1629 CRESTVIEW CT

Re: Application for improvement permit for 1629 Crestview Court
Health Department file no. 4492B

SOIL/SITE EVALUATION
for ON-SITE WASTEWATER SYSTEM

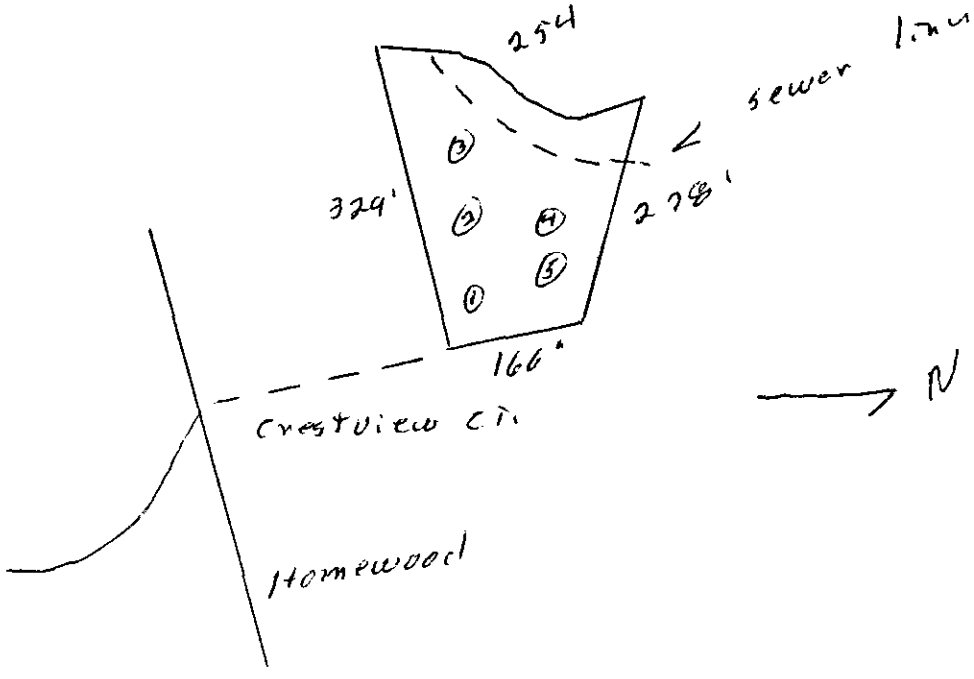
PROFILE #	Slopes 5-12% .1940 Landscape Position/ Slope %	Horizon Depth (IN.)	SOIL MORPHOLOGY (.1941) .1941 STRUCTURE/ TEXTURE	SOIL MORPHOLOGY (.1941) .1941 CONSISTENCE MINERALOGY	OTHER PROFILE FACTORS .1942 SOIL WETNESS/ COLOR	OTHER PROFILE FACTORS .1943 SOIL DEPTH	OTHER PROFILE FACTORS .1956 SAPRO CLASS	OTHER PROFILE FACTORS .1944 RESTR HORIZ	PROFILE CLASS &LTAR
1	LS	0-2"	gr/scl	Fr/SE/P/ss/sp	75" TO soil wetness	5"	N/A	None	US
		2-5"	sBkC	vFi/Mixed/us/vp					
2	LS	0-2"	gr/scl	Fr/SE/P/ss/sp	74" TO soil wetness	4"	N/A	None	US
		2-4"	sBk/C	vFi/SE/P/us/vp					
3	LS	0-2"	gr/scl	Fr/SE/P/ss/sp	716" TO soil wetness	16"	N/A	None	US
		2-16"	sBkC	vFi/SE/P/us/vp					
4	LS	0-4"	gr/scl	Fr/SE/P/ss/sp	716" TO soil wetness	16"	N/A	None	US
		4-16"	sBk/C	vFi/Mixed/us/vp					
5	LS	0-3"	gr/scl	Fr/SE/P/ss/sp	714" TO soil wetness	14"	N/A	None	US
		3-14"	sBkC	vFi/Mixed/us/vp

SITE CLASSIFICATION (.1948): Unsuitable

COMMENTS 100% repair, sewer line crosses property
